## **NOTICE OF A TYPE IX DECISION ON A PROPOSAL IN YOUR NEIGHBORHOOD**

### **CASE FILE NUMBER: LU 13-241486 LDP**

**Updated Proposal:** The applicant requests a **Land Division-Partition** to divide an approximately 19,800 square foot property into 2 parcels. Parcel 1 will be approximately 9,793 square feet in area. Parcel 2 will be approximately 9,795 square feet. A 2-foot right-of-way dedication is proposed along the SW Nevada Court frontage.

PRELIMINARY SITE/  
 UTILITY PLAN  
**TREE PRESERVATION**

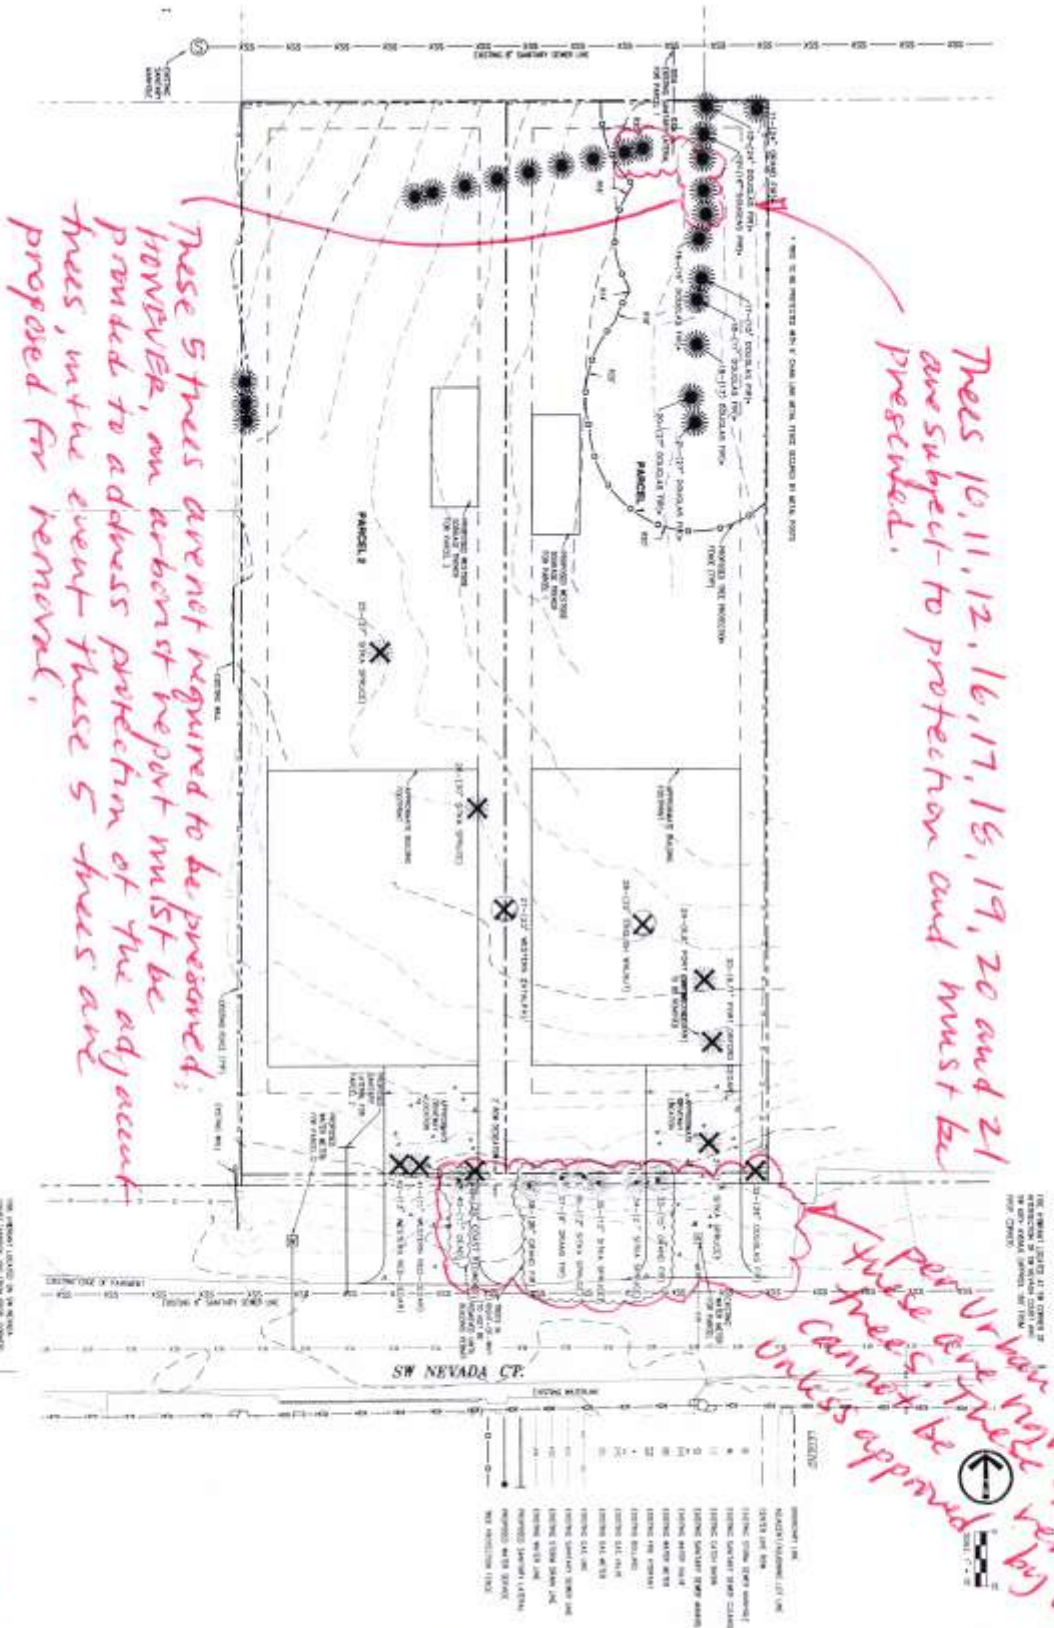
These 5 trees are not required to be preserved; HOWEVER, an arborist report must be provided to address protection of the adjacent trees, in the event these 5 trees are proposed for removal.

Trees 10, 11, 12, 16, 17, 18, 19, 20 and 21 are subject to protection and must be preserved.

Per Urban Forestry  
 these are right-of-way  
 trees. These trees  
 cannot be removed  
 unless approved by Urban Forestry.

amended by BDS staff  
 version 4 July 15, 2019
